9310 Brockville Rd. Hwy 30/2-07A
Silver Springs

SUBJECT: Historic Area Work Permit #456450 -- Alterations

MONTGOMERY COUNTY HISTORIC PRESERVATION COMMISSION
STAFF REPORT

PROPOSAL: Reconstruct window well and install gutters

Examples of traditional style collector boxes proposed for the front gusset.

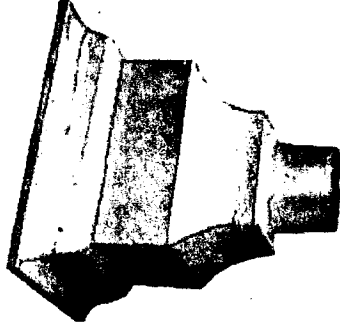
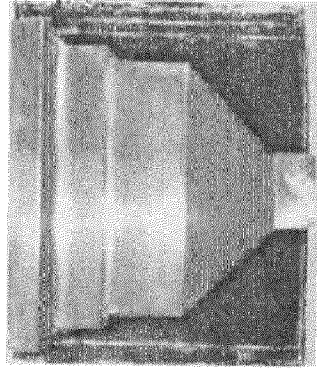
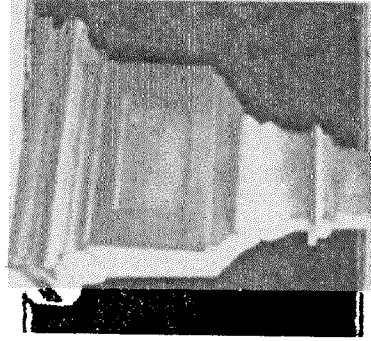
APPROVED
Montgomery County
Historic Preservation Commission
Re: [Signature]

View of subgreenhouse with proposed reconstructed window well and panel windows

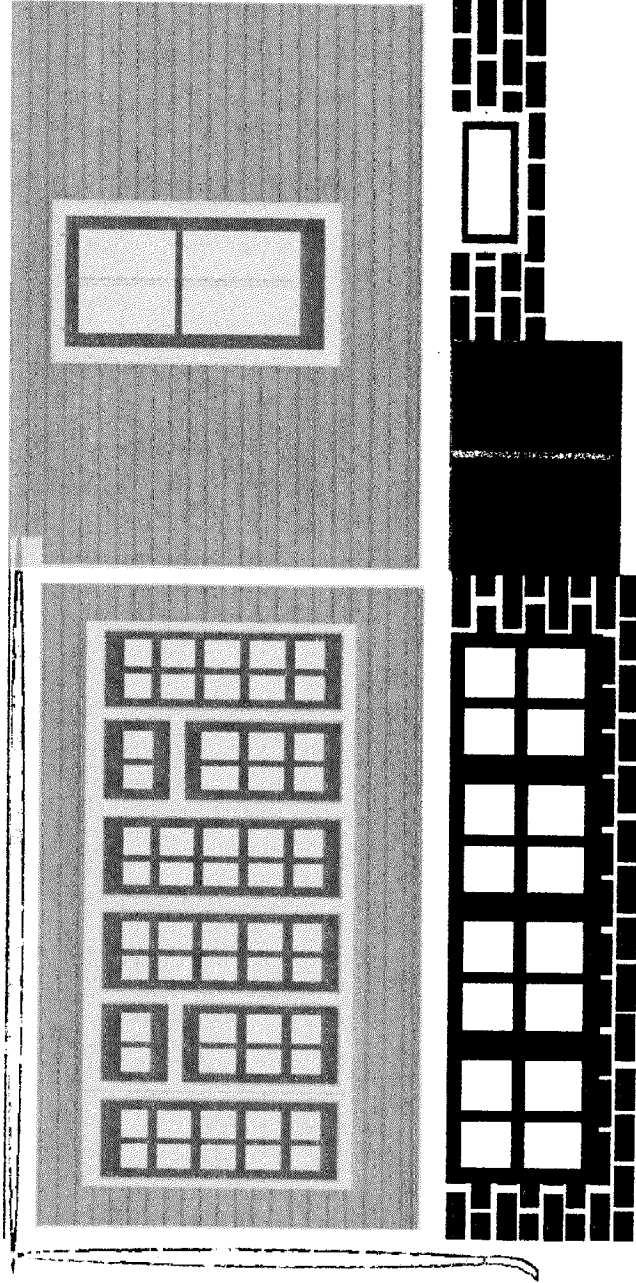
APPROVED
Montgomery County
Historic Preservation Commission
A. F. [Signature]

View of greenhouse side showing restored brick piers, window well, and installed panel windows

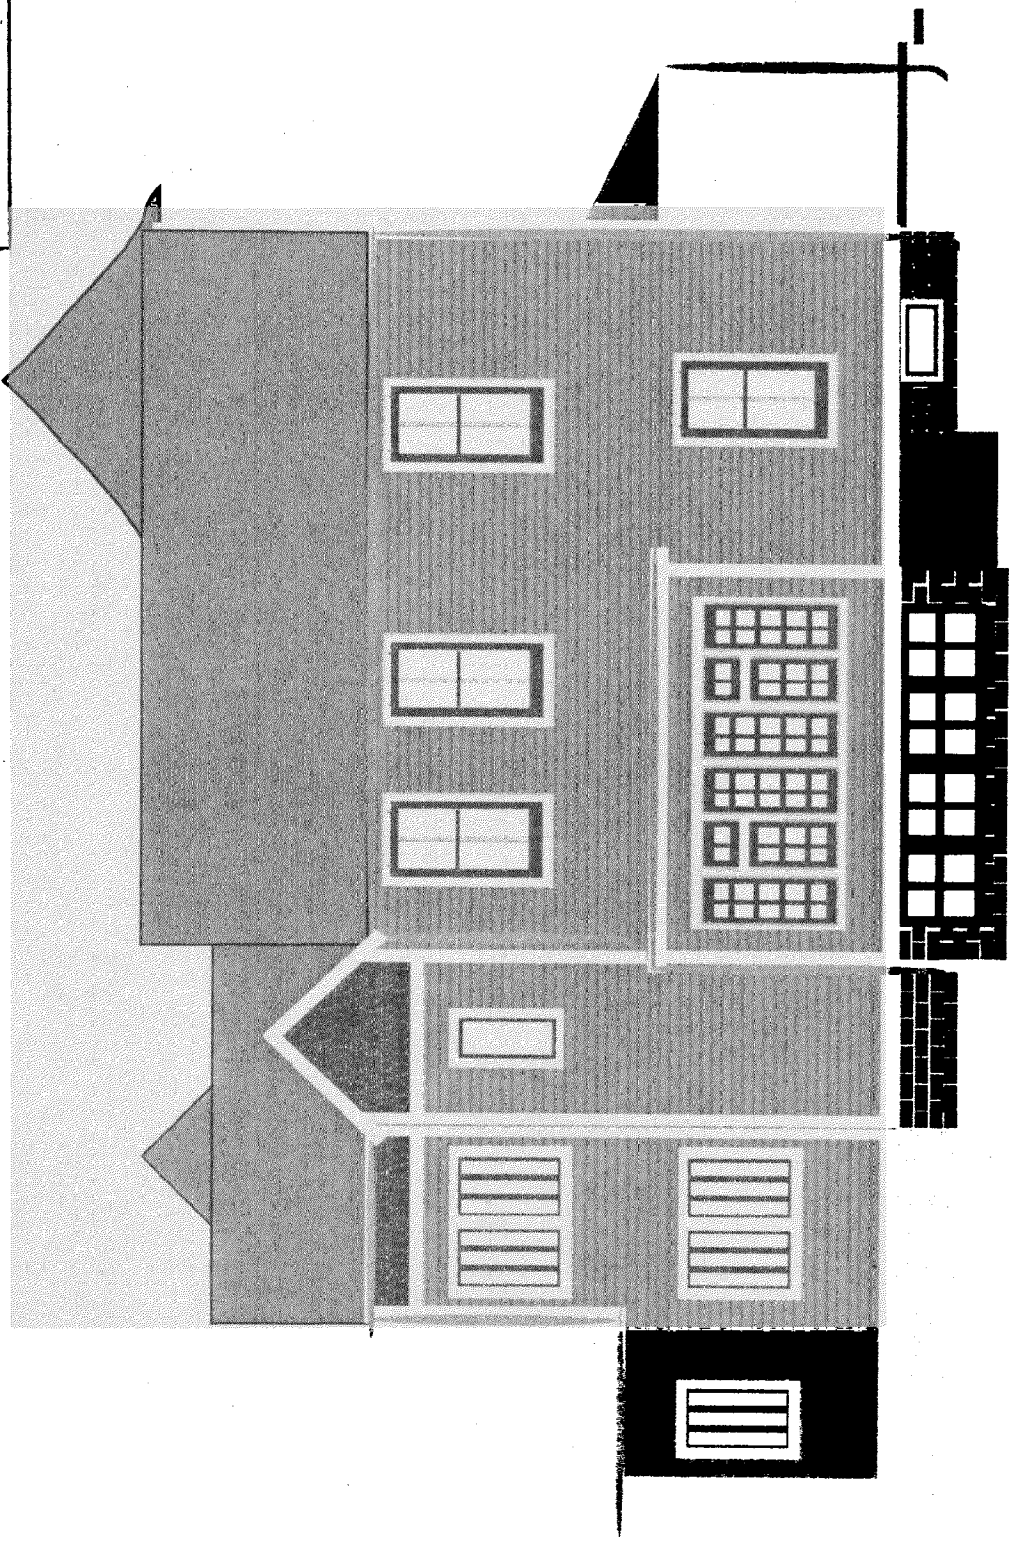
APPROVED
Montgomery County
Historic Preservation Commission
A. F. F. F. F.

Front view showing:

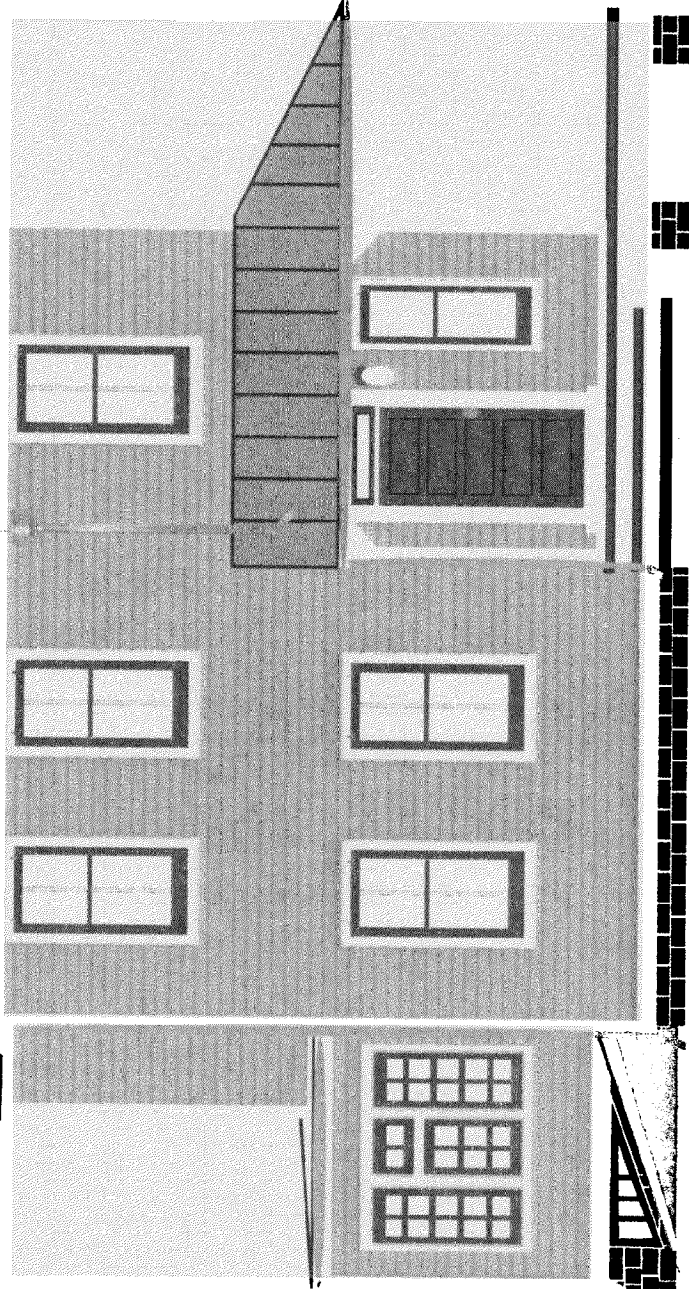
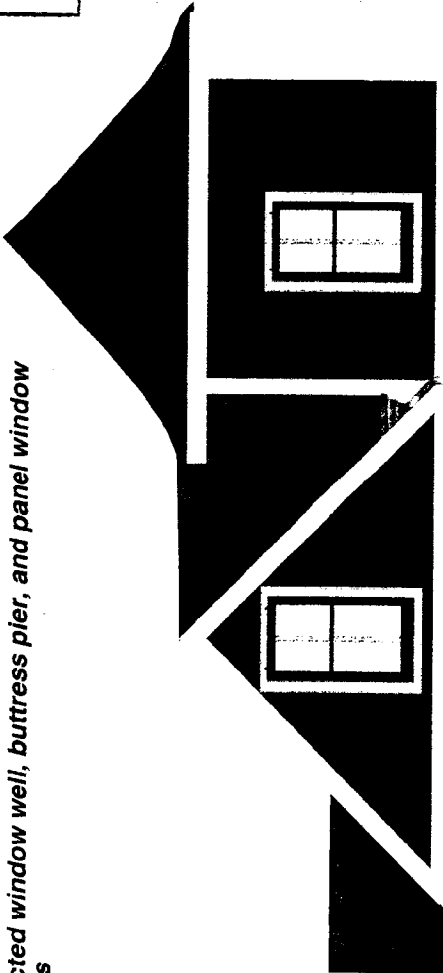
APPROVED
Montgomery County
Historic Preservation Commission
